Re: **Vegetation Protection and Restoration Plan Addendum & Response #1 to Peer Review
Comments– 537086 Main Street, Horning’s Mills, Township of Melancthon
(Project No. 300056814.0000)**

Azimuth Environmental Consulting, Inc. (Azimuth) has reviewed peer review comments prepared by R.J. Burnside & Associates Limited (“Burnside”) on behalf of the Township of Melancthon (the “Township”) with regard for a Vegetation Protection and Restoration Plan (VPRP) prepared by Azimuth for a proposed residential development at 537086 Main Street (Horning’s Mills), dated April 29, 2024.

The purpose of this letter is to provide a detailed VPRP Addendum & Response #1 to consolidated peer review comments, based on a revised development planning materials (*e.g.* Draft Plan of Subdivision, Grading Plan) prepared by the project team in October 2025. Peer review comment/responses are also detailed in an accompanying comment matrix submitted in parallel with this VPRP Addendum, under a separate cover. Azimuth also prepared a separate Scoped Environmental Impact Study (EIS) related to the proposed development concept, dated April 16, 2024. Consolidated peer review comment responses related to the Scoped

VEGETATION PROTECTION PLAN

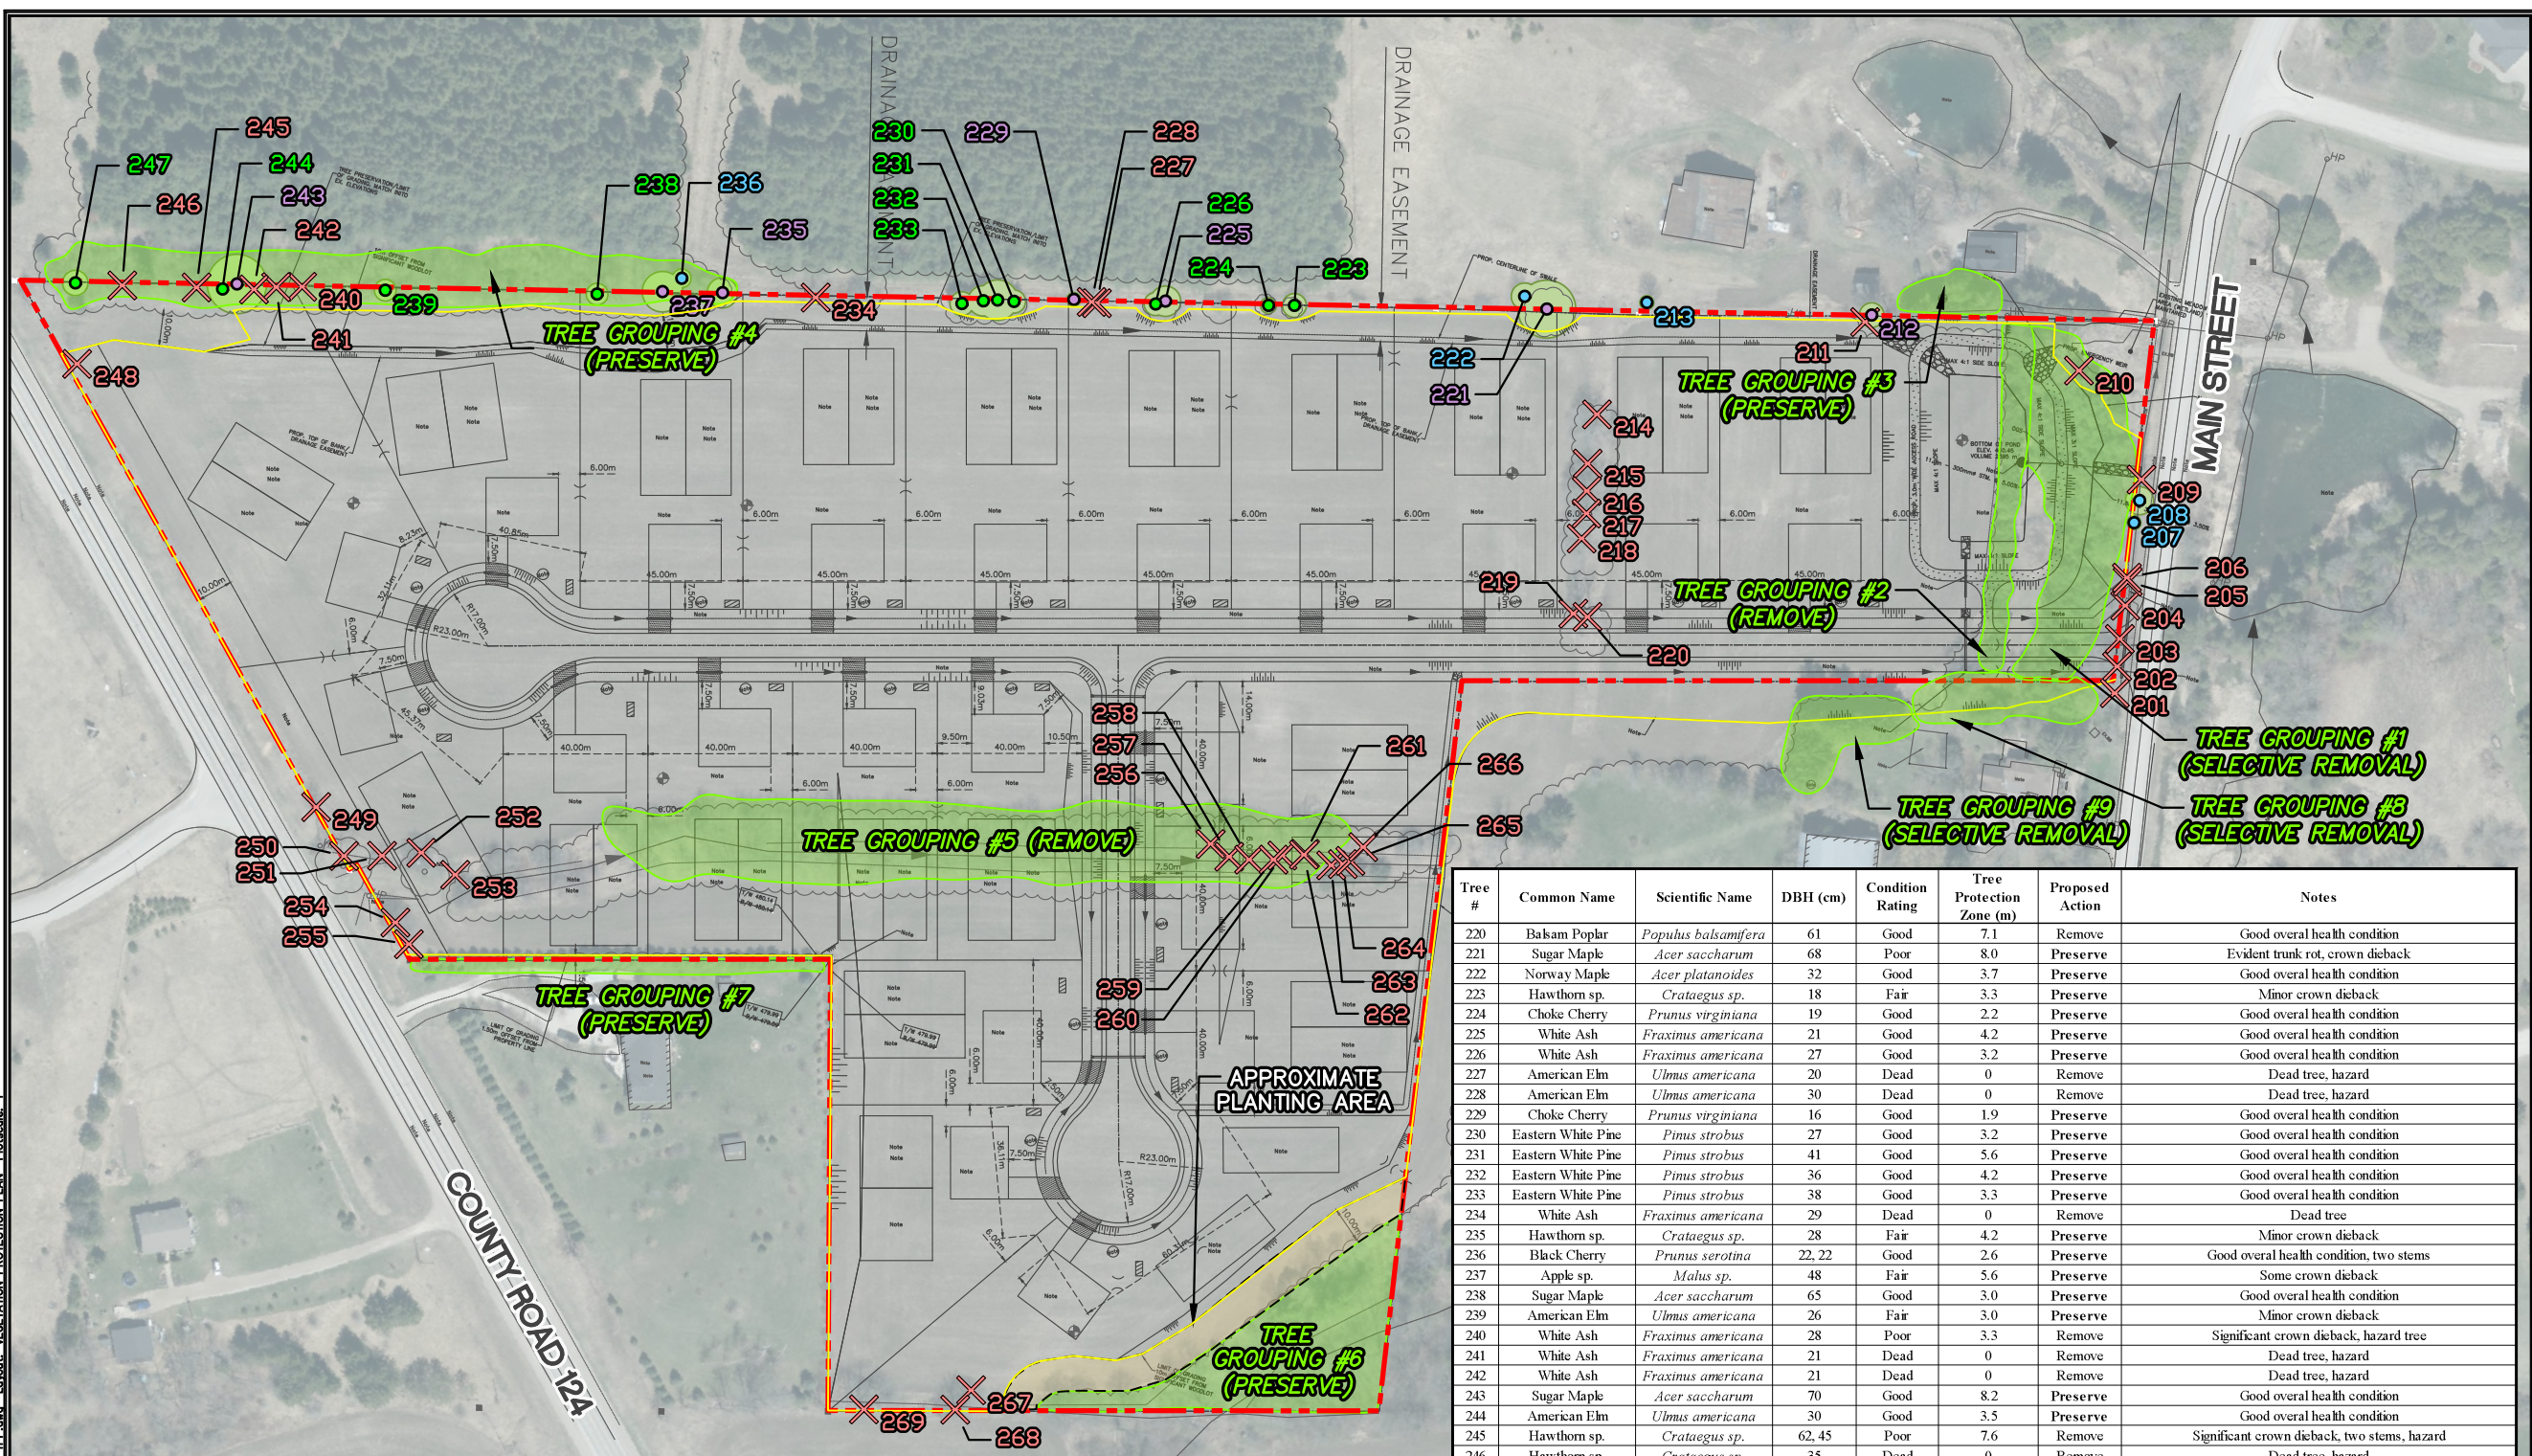
The adjacent residential property at the south west corner of the subject property is surrounding by a coniferous hedgerow. Grading is planned to the property line and could affect boundary trees. Please clarify how these trees will be protected.

The location of tree protection fencing appears as though it may interfere with construction of the drainage swale along the northern property boundary. The tree protection fencing should be inspected by an arborist to ensure that it is installed correctly. The constructability of the drainage swale should be reviewed to ensure there is no conflict between tree protection and swale construction.

The adjacent residential property at the southwest corner of the subject property is surrounded by a coniferous hedgerow. Grading is planned to the property line and could affect boundary trees. Please ensure that an adequate root protection zone will be respected.

The tree protection fencing appears to cross through the wetland in the northeastern corner of the site. No work should occur within the wetland. Please move the tree protection fencing outside of the wetland and its buffer.

The proposed edge of grading and associated tree protection fencing have been revised in the southwest property adjacent the hedgerow to permit an additional 1.5m of setback to the property line on the north edge of the property in this location, where the grading is closest to the trees. This is reflected in the updated Figure 2A of the Vegetation Protection and Preservation Plan (attached). The maximum tree size in this hedgerow is 25cm DBH, as noted in Table 2, Figure 2, and these trees were noted to be located on adjacent lands (*i.e.* south of the property boundary), albeit very close to the property boundary. Therefore, given the maximum tree size, ensuring a minimum of 1.5m along this line preserves a minimum of 75% of any single Tree Protection Zone of a tree in this hedgerow, preventing harm to these trees in a post-construction scenario. This revised grading and tree protection fencing is consistent with the standards of Section 4.0 of the Vegetation Protection and Preservation Plan.

The alignment of the tree protection fencing, limit of grading and swale positioning along the north property boundary have been revised to avoid conflicts between grading, tree protection and swale construction. See updated Figure 2A of the Vegetation Protection and Preservation Plan.

Refer to Azimuth response to Burnside EIS Comment #2 above.

Figure 2 (Vegetation Protection Plan) has been corrected to ensure Tree Protection Fencing does not cross through the retained wetland feature and its buffer in the northeast portion of the property.

Table 2: Tree Grouping Inventory and Assessment Table

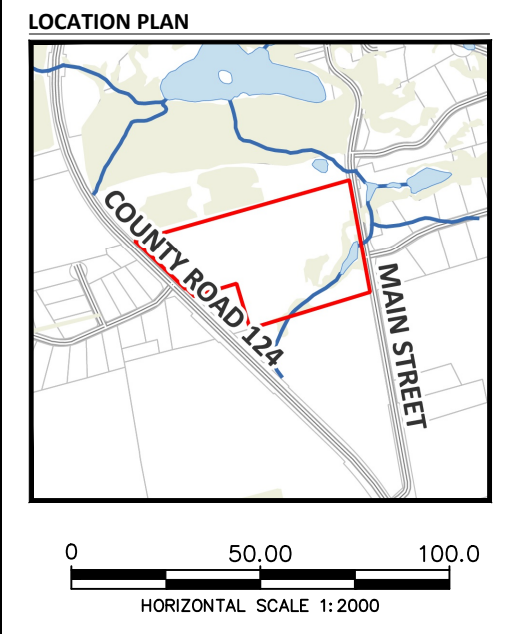
The limit of grading appears to extend beyond the property limits south of the SWM pond. If this is correct, please include in the report the trees on the adjacent property which will be removed to accommodate this grading.

The limit of grading is correctly depicted as extending beyond the property limits south of the SWM pond. A supplementary site visit was completed on November 3, 2025 (D. d’Entremont) to collect information relating to these additional tree groupings (Tree Groupings #8 and #9), focused on trees within 6m of the limit of grading and trees with potential to be impacted by grading. Figure 2 of the Vegetation Protection and Preservation Plan has been divided into Figures 2A and 2B, which have been updated with information relating to Tree Groupings #8 and #9, including characterization of the extent of associated removals.

Based on the footprint of proposed grading south of the property boundary, thirty (30) trees associated with Tree Grouping #8 and fourteen (14) trees associated with Tree Grouping #9 are expected to require removal. Further, based on the proposed outflow on the SWM pond to the east towards Main Street, Azimuth also notes that Tree #209 will require removal. Based on a 1:1 tree replacement ratio noted in Burnside VPRP Comment #3, 45 trees have been added to the proposed planting plan to accommodate removals associated with Tree Groupings #8, #9, and Tree #209. Combined with the original 72 compensation trees + 15 additional trees required by Burnside VPRP Comment #3, a total of 132 compensation trees are now included in the updated Figure 3.

VEGETATION RESTORATION PLAN

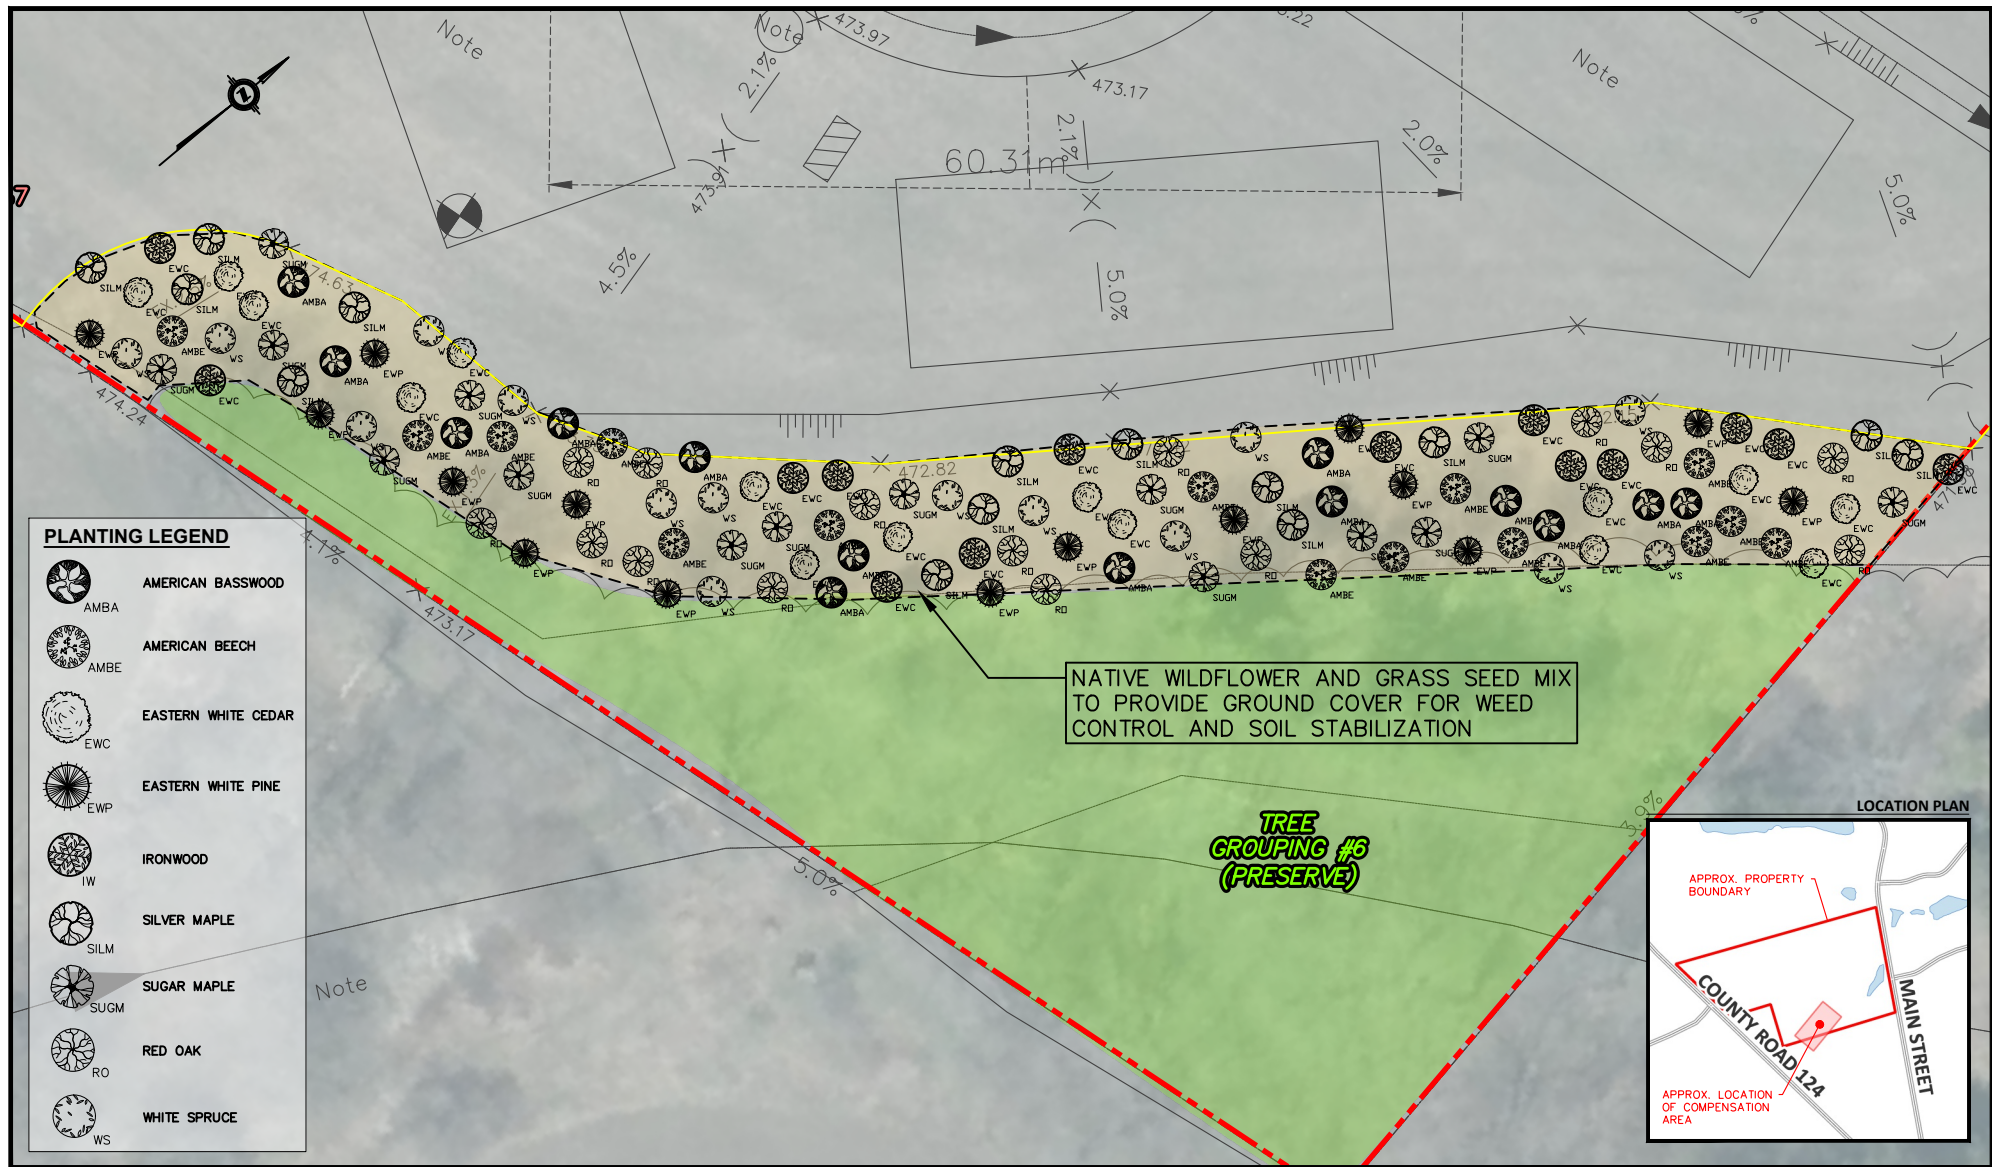
The number of trees proposed for removal is unclear as large numbers of trees were “grouped” rather than being counted individually. A total of 72 new trees are proposed to be installed. It appears as though more trees will be removed than replaced. We recommend planting at least 15 more trees to more closely achieve a 1:1 tree replacement ratio.

In addition to the original 72 compensation trees, 15 additional trees have been included within the compensation planting area to address the above comment.

It should also be noted that, in addition to the above, another 45 trees have been added to the compensation as discussed within Azimuth’s response to Burnside VPRP Comment #4 (below). Refer to updated Figure 3 of the Vegetation Protection and Preservation Plan. The adjusted total number of trees required for compensation has been updated to 132 to accommodate these revisions.
